Fire and Rescue Station Paving

ADDENDUM NO. 3

**Addendum No. 3
IFB 2022-021
Fire and Rescue Station Paving**

CATAWBA FIRE STATION PAVING PLAN

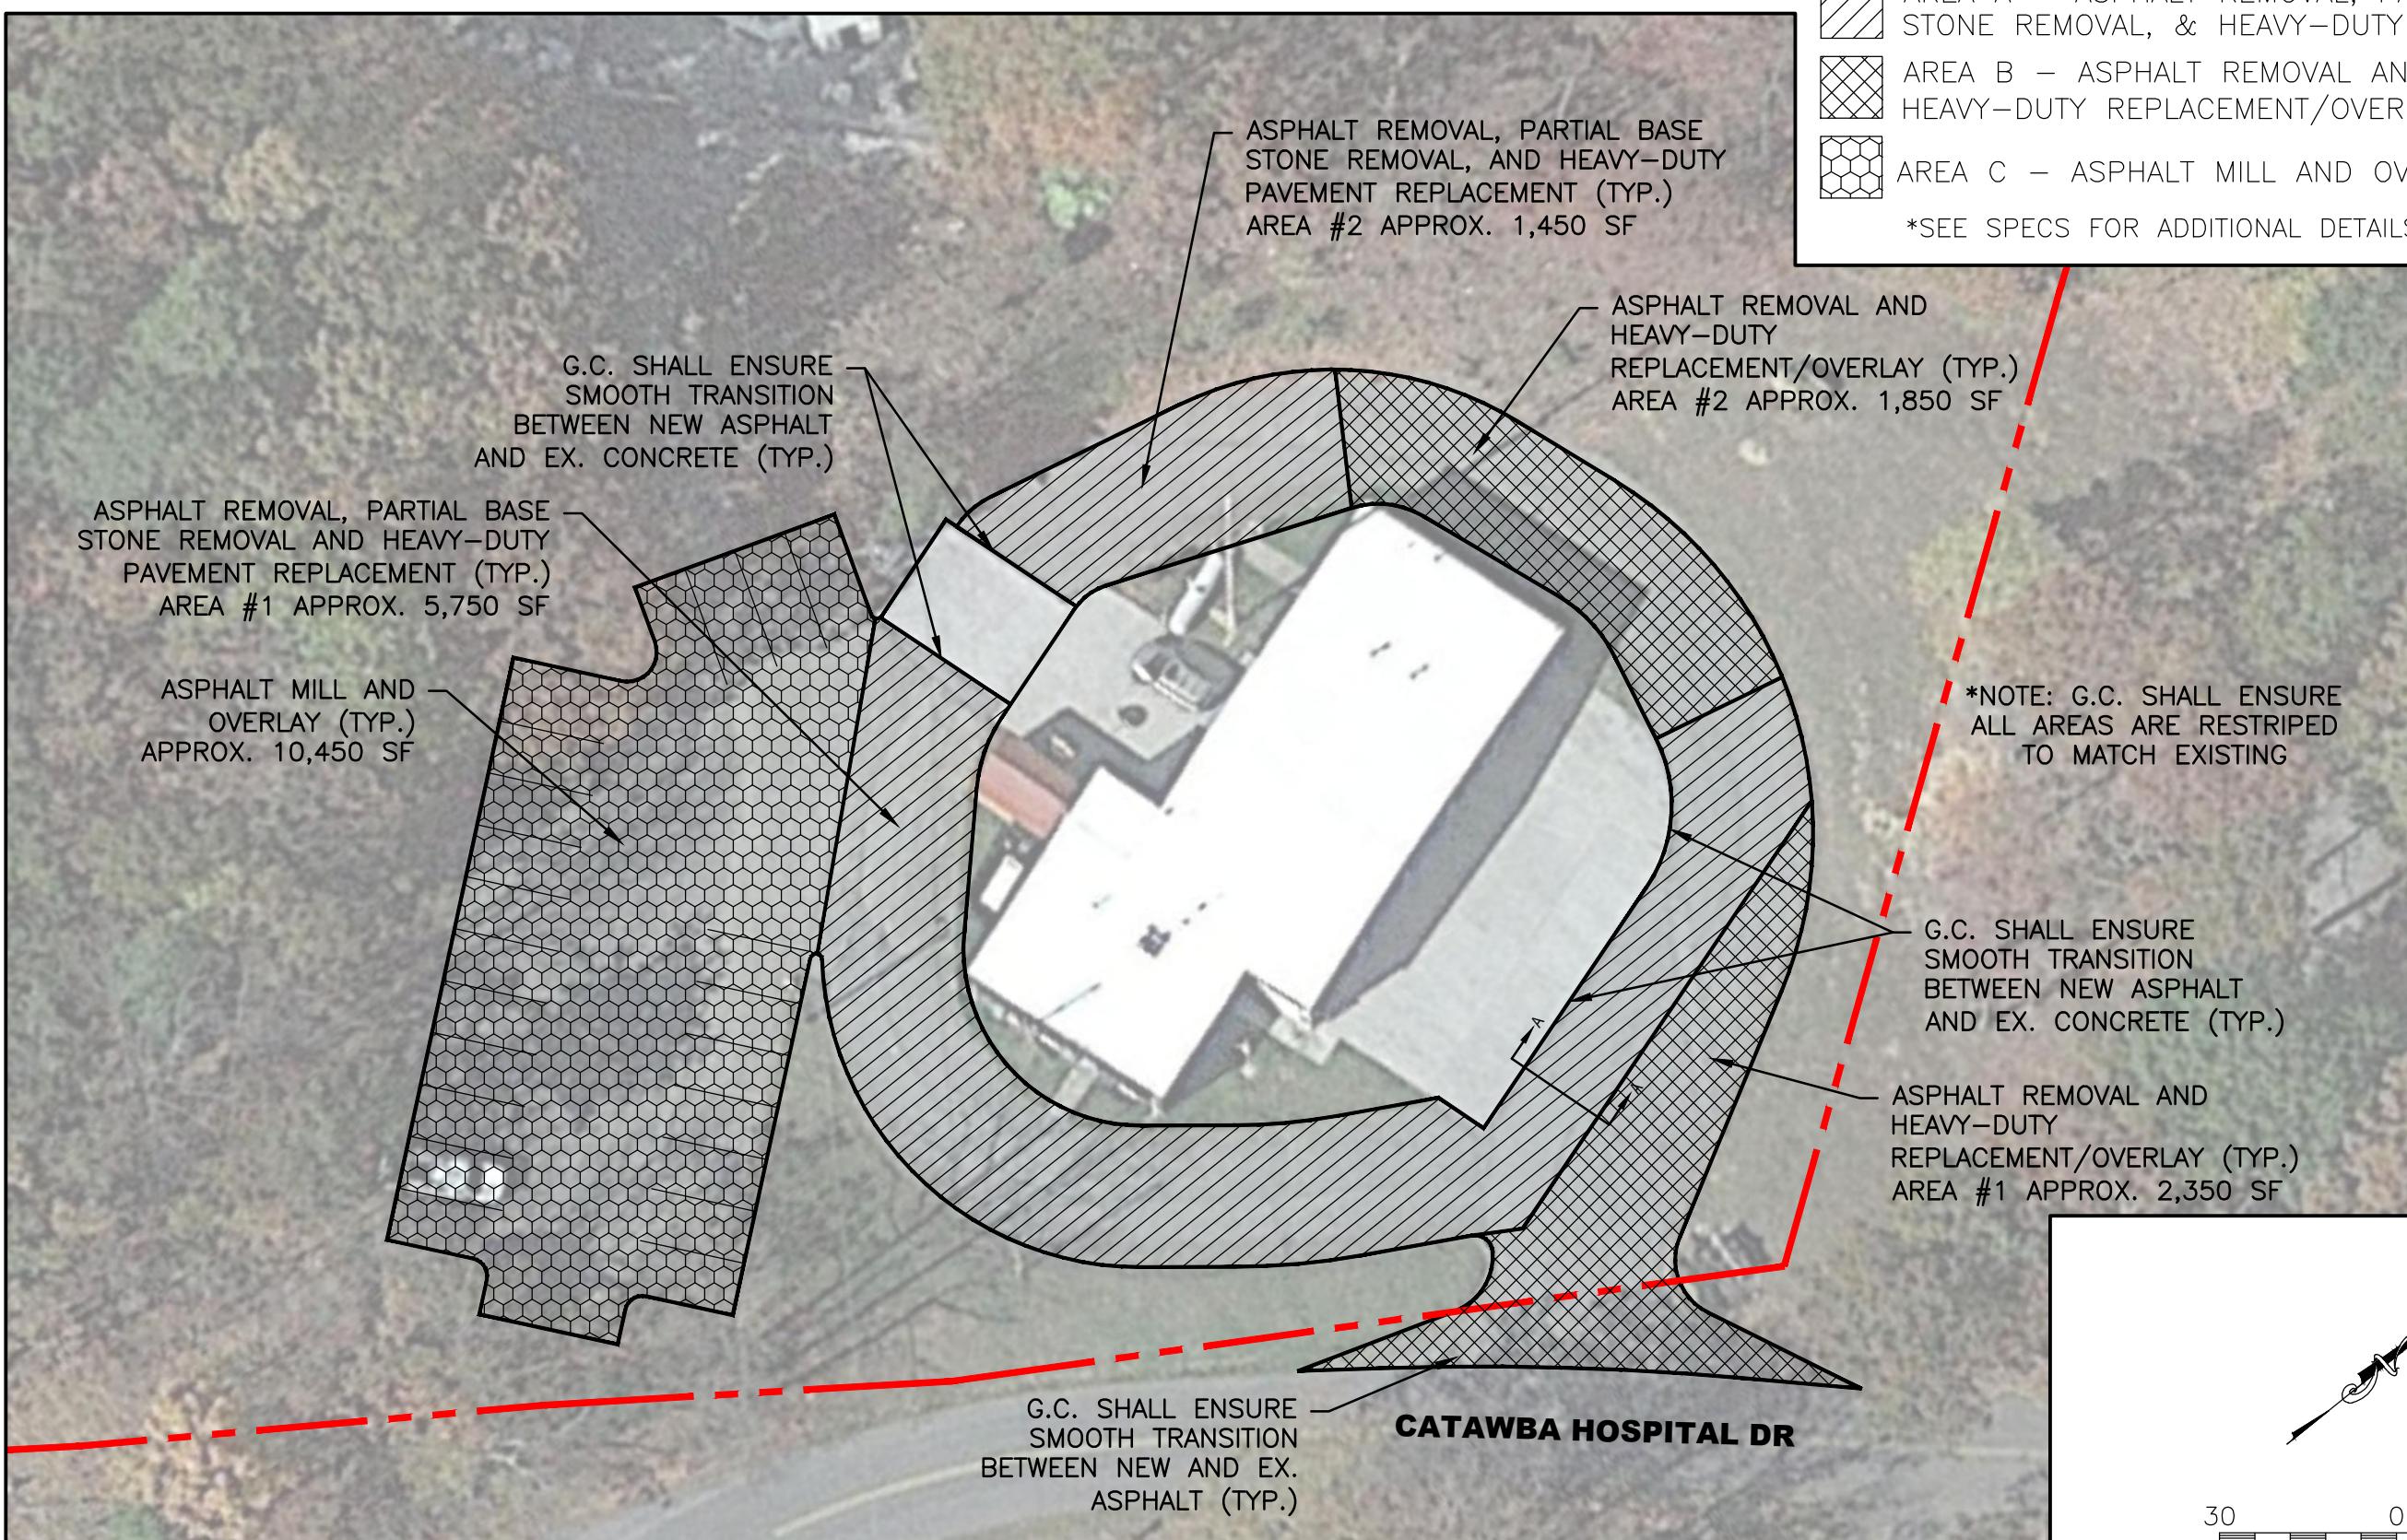
Change in Scope and New Bid Form
Due Date & Time:
October 21, 2021 2:00PM
(Local Prevailing Time)

1. New Bid Form-Please use this Bid Form instead of the one included with the original Bid.
2. Take note of attached Scope of Work.

Area A – Asphalt Removal, Partial Base Stone Removal, & Heavy-Duty Replacement

- Removal of approximately 7,200 s.f. of existing asphalt areas as identified on the Concept Plan (approximate 2" – 2.5" depth). Removal of underlying base stone as necessary to allow for installation of 4.5" of new asphalt and maintain existing top of pavement elevation as necessary to maintain appropriate tie-ins and drainage patterns.
- Proofroll of the underlying stone base using a tandem axel, fully-loaded dump truck with County's Geotechnical Engineer present (G.C. to coordinate schedule with Owner).

Area B – Asphalt Removal & Heavy-Duty Replacement/Overlay

- Removal of approximately 4,200 s.f. of existing asphalt areas as identified on the Concept Plan (approximate 2" depth).
- Proofroll of the underlying stone base using a tandem axel, fully-loaded dump truck with County's Geotechnical Engineer present (G.C. to coordinate schedule with Owner).
- Installation of 3" (not to exceed 3.5") compacted depth asphalt base course using BM-25.0 bituminous pavement and 1.5" (not to exceed 2") compacted depth asphalt surface course using SM-9.5A bituminous pavement.
- Installation of base and surface courses of asphalt will raise the finished grade of the paved areas by approximately 2" – 2.5". Contractor shall ensure smooth transitions between these areas and the adjacent paved areas and shall ensure that drainage patterns are maintained.

Area C – Asphalt Mill & Overlay

- Milling of approximately 10,450 s.f. of existing paved areas as identified on the Concept Plan. Milling shall include the entire existing surface course (approximate 2" depth).
- Proofroll of the underlying stone base using a tandem axel, fully-loaded dump truck with County's Geotechnical Engineer present (G.C. to coordinate schedule with Owner). Owner shall be notified of any issues identified with the existing stone base requiring remediation.
- Installation of min. 2" (not to exceed 2.5") compacted depth asphalt surface course using SM-9.5A bituminous pavement. Include a tack coat between the base stone and new asphalt.

- Installation of 3" (not to exceed 3.5") compacted depth asphalt base course using BM-25.0 bituminous pavement and 1.5" (not to exceed 2") compacted depth asphalt surface course using SM-9.5A bituminous pavement.
